North – South Cycle Superhighway, London

Road Safety Audit Stage 3

on behalf of City of London

TMS reference no: 12809

Appendix A

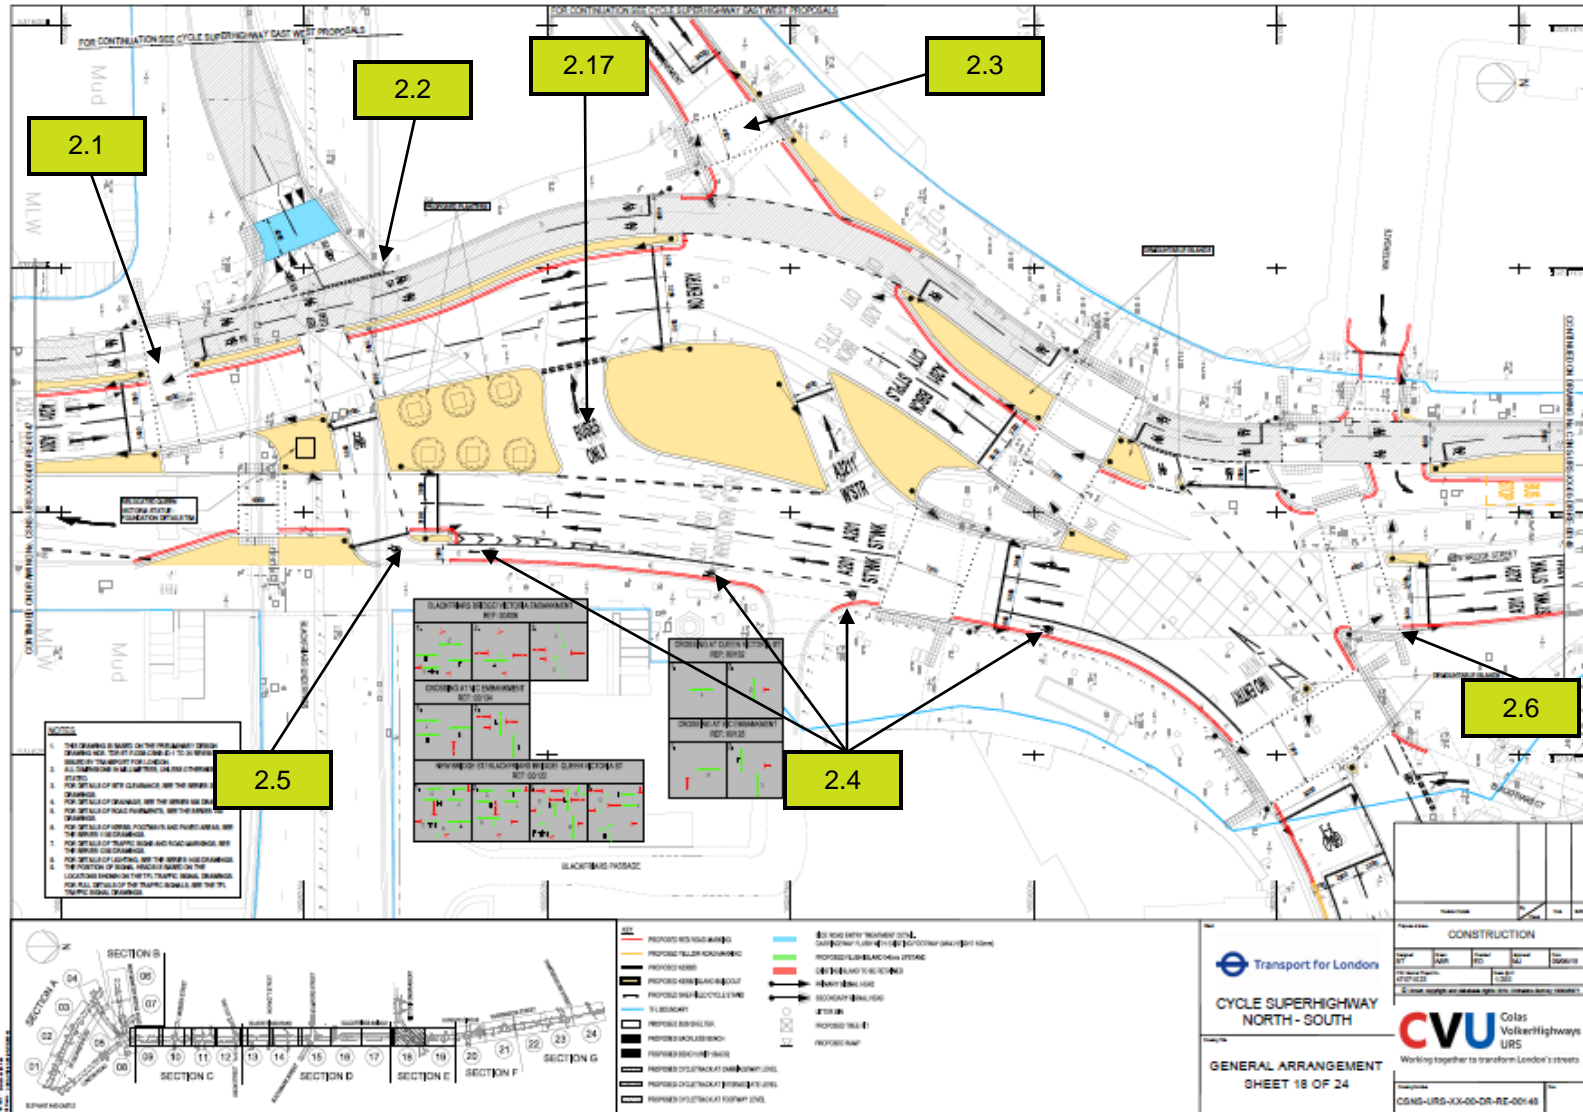
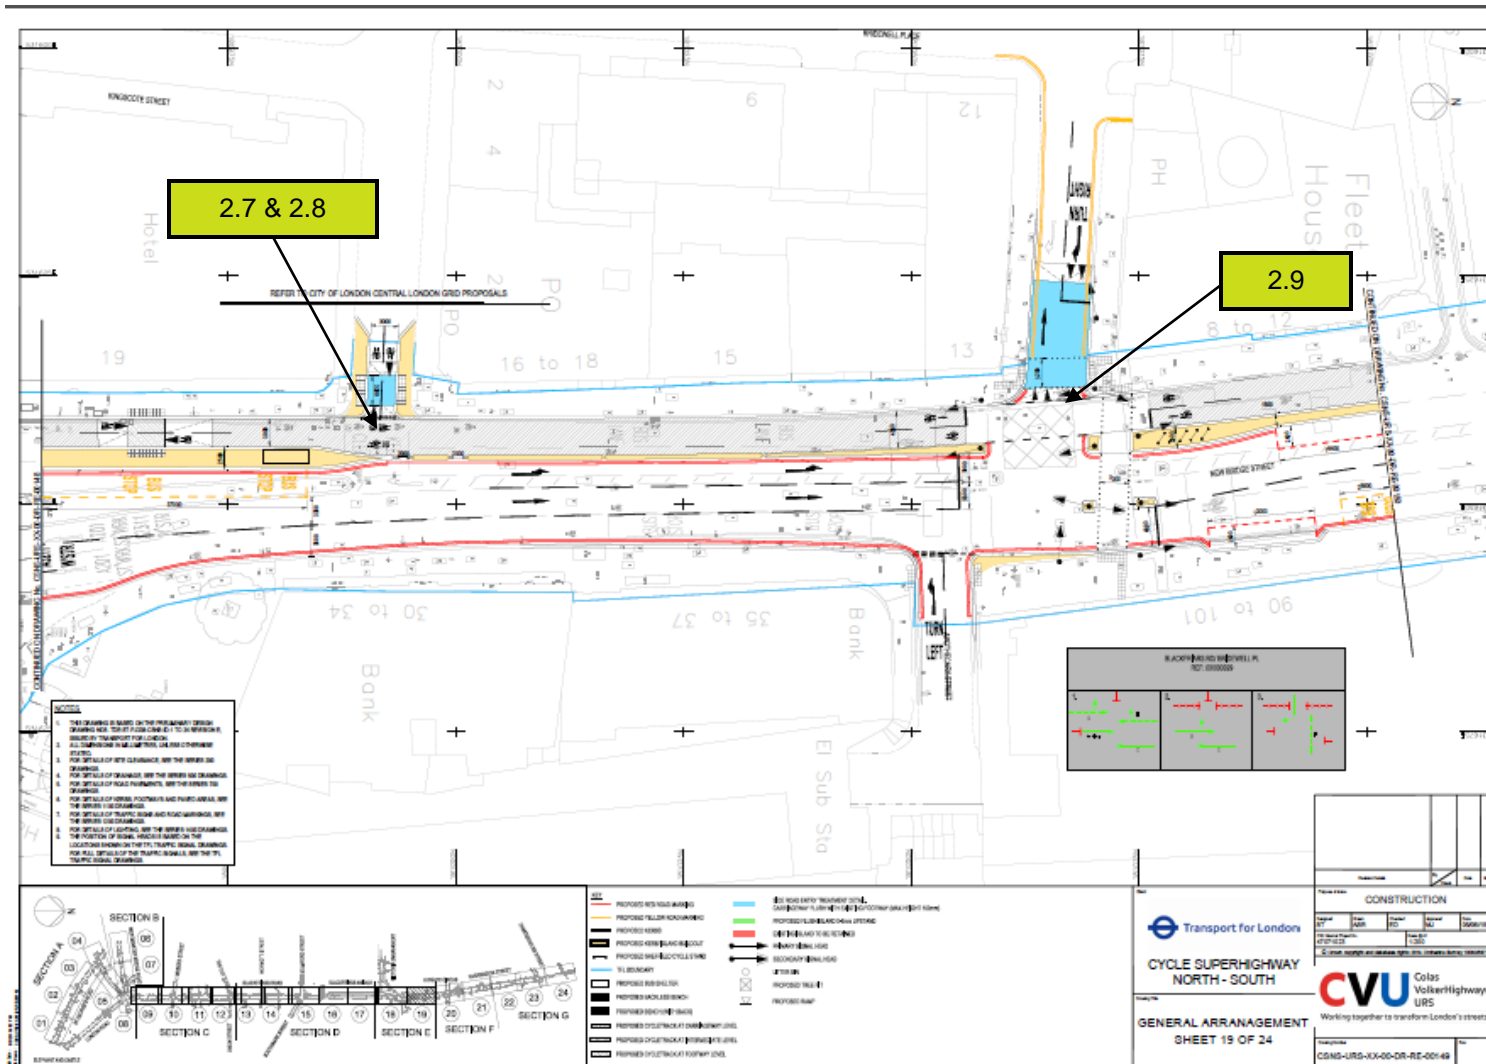
It was noted at the site visit that whilst a large percentage of cyclists are compliant with the CSH signals, a small number or continuing to travel through the red signal. This was particularly noticeable at the controlled pedestrian crossing that crosses CSH 6 on the northern side of Blackfriars Bridge. Pedestrians using the crossing will be at risk of being struck by cycles if cyclists continue to proceed through a red signal.

There is a pole located within the footway that does not feature a sign. It is unclear if the pole is redundant or new and awaiting installation of a sign face. However, the pole is within the middle of the footway and as such is a hazard and obstruction to pedestrians, particularly to those with visual or mobility impairments.

The Victoria Embankment on / off slip road is two-way. The Audit Team has been informed that this was previously only one-way, which is why there is a need for temporary 'Pedestrians Look Both Ways' signs at the controlled crossing at the top of the slip road at the junction with the A201. These temporary signs may in time get stolen, fall over or become displaced. Some pedestrians when using the crossing may be expecting traffic in one direction only, which may result in pedestrians stepping out into the carriageway in front of oncoming traffic.

There is a long length of mandatory cycle lane on the east side of the A201 from Queen Victoria Street outside Blackfriars Station prior to the cycle switch over to CSH 6. However, there are no cycle symbol markings in this lane. The lack of markings may lead to the cycle lane being misused by other vehicles, leading to vehicle/cycle collisions.

Although it appeared to be well used and understood at the time of the site visit, the switch to take cyclists from the cycle lane on the southbound A201 across to the East – West CSH and CSH 6 is a critical section of the route. Temporary signs are in place at present, however these signs may in time get stolen, fall over or become displaced. New cyclists may not comprehend the layout, with confusion leading to collisions with other road users.

It was noted at the time of the site visit that neither of the push button demand units, and associated rotating cones, on the east side of the pedestrian crossing on New Bridge Street were working. Visually impaired pedestrians may be vulnerable when attempting to cross at this location as they have no control or tactile aid to help them use the crossing. Vehicle/pedestrian collisions may result if pedestrians attempt to cross during traffic phases.

The layout of the junction of New Bridge Street with Tudor Street is in a temporary state. The General Arrangement shows that Tudor Street is to be closed off to vehicular traffic, however, in its temporary state vehicles can egress from Tudor Street and make a left turn manoeuvre onto New Bridge Street. Although only observed on a small number of occasions (both am and pm peak periods), drivers wait at the give way, check for cyclists before crossing CSH 6 and wait for a gap to complete their manoeuvre. These have been carried out without conflict with cyclists and the vehicles involved have either been private cars, taxis or light goods vehicles. However, in the event that a large vehicle was to carry out this manoeuvre, they could end up blocking the CSH 6 for a longer period of time, increasing the likelihood of collisions with cyclists.

During the site visit in darkness, it was noted that the general area of New Bridge Street junction with Tudor Street was quiet dark, due to a number of lighting columns not being illuminated, most noticeably the floodlight column in the median strip between CSH6 and the main carriageway, just to the south of Tudor Street. Poor illumination of the junction in darkness may exacerbate the risk of collisions as described in Problem 2.7.

There are a number of prohibited movements at the A201 new Bridge Street junction with Bridewell Place all currently signed with temporary signs. However these signs may in time get stolen, fall over or become displaced leaving drivers / cyclists unaware of the restrictions. Collisions may occur between all road users if drivers / riders fail to appreciate the prohibited movements.

On exit from Bride Lane, temporary signs have been placed on the footway (red cycle warning symbol with uni-directional arrows) to show warn drivers that they are going to egress across CSH6. These signs are not consistent with the 'Cycle Lanes Look Both Ways' signs used at other locations throughout the scheme (i.e. Tudor Street). The red cycle warning sign is not as clear to drivers that they have to cross a cycle lane. Misleading information may lead to vehicles pulling out of Bride Lane into the path of cyclists on the CSH6.

Northbound drivers on the A201 New Bridge Street approach to the junction with Fleet Street / Ludgate Hill, drivers and cyclists are informed that there is a right turn prohibition into Ludgate Hill 'except in two stages'. The Audit Team has been informed that there is a bus route that requires right turn manoeuvres from A201 New Bridge Street into Ludgate Hill. Vehicle collisions may occur if other drivers are not expecting buses to make right turn manoeuvres.

During the site visit in darkness, it was noted that the general area of the A201 New Bridge Street / Fleet Street / Ludgate Hill junction was quite dark, due to a number of lighting columns not being illuminated. Poor illumination of the junction may result in darkness related vehicle collisions.

On the east side of Farringdon Street adjacent to Bear Alley, the southbound cycle track diverges away from the main carriageway. This is to enable cyclists to make the switch from the southbound cycle track across to CSH6. This area has not been constructed as per general Arrangement Sheet 21. The open nature of this area may be 'inviting' for drivers to enter / park, which may result in vehicle/cycle collisions.

As well as in the specific locations identified in Problems 2.3, 2.5 and 2.9, the signage in general along the route is all temporary. However these signs may in time get stolen, fall over or become displaced, leaving drivers / cyclists unaware of restrictions, turning prohibitions, cycle tracks etc. Poor comprehension of the road layout may result in collisions between all road users.

It was noted that whilst unavoidable, there was a large number of metal service covers located within the CSH 6 route. Metal service covers can become polished in time and therefore a potential slip / skid hazard to cycles, particularly in wet or icy conditions. This issue may be exacerbated as cyclists travel at speed along the route. Given the high usage of the route, in the event that a rider becomes de-stabilised and falls from their cycle, there is a risk of being struck by other cyclists on the route.

As well as the specific locations identified in Problems 3.8 and 3.12, it was noted there were a number of intermittent lighting columns not illuminated during the site visit in darkness, particularly on the section north of Blackfriars Bridge. Poor illumination may result in darkness related collisions between all road users.

A 'buses only' right turn lane pocket is provided to enable buses to make U-turns from A201 southbound to northbound at the north side of Blackfriars Bridge. However, 'buses only' is marked on the carriageway and the upright signs states 'buses and taxis'. This should be clarified and a consistent signage or road marking provided.

It is acknowledged that the scheme is new and a high proportion of cyclists are compliant with the signals. However, enhanced signage should be provided or greater enforcement should target red light running of cyclists.

The pole should be removed if redundant. If still required for a new sign, the pole should be relocated to the rear of the footway.

Permanent 'Look Both Ways' carriageway markings should be provided on both sides of the crossing.

Cycle symbol markings should be provided in the cycle lane at regular intervals (as per General Arrangement Drawing 18).

Permanent signs should be provided for guidance to cyclists.

The push button demand units and rotating cones should be checked and repaired as necessary.

The feasibility of closing off Tudor Street at its junction with New Bridge Street should be assessed, assuming that vehicles have alternative routes to exit from the Temple Area.

Alternatively, if the left out manoeuvre is to remain permitted for vehicles, all of the existing temporary signage at the junction should be replaced with permanent signage, and transverse give way markings installed at the entry into the general traffic lane, similar to the Bride lane junction with New Bridge Street.

Localised lighting should be checked and lighting units repaired as necessary.

The temporary signs should be replaced with permanent signs.

The temporary signs should be replaced with permanent 'Cycle Lanes Look Both Ways' signs to be consistent with the rest of the route.

The requirement for buses to make the right turn from A201 New Bridge Street into Ludgate Hill should be clarified and if necessary 'except buses' should be added to the traffic signals.

Localised lighting should be checked and lighting units repaired as necessary.

This area should be formalised with appropriate signage (it is noted that there is a sign pole present without a sign face), carriageway 'cycle symbols', and different coloured surfacing to highlight the area as being for cyclists only.

The temporary signage should be replaced with permanent signs.

The feasibility of treating all the metal service covers along the CSH 6 route with a non-slip surface should be investigated.

Localised lighting should be checked and lighting units repaired as necessary.
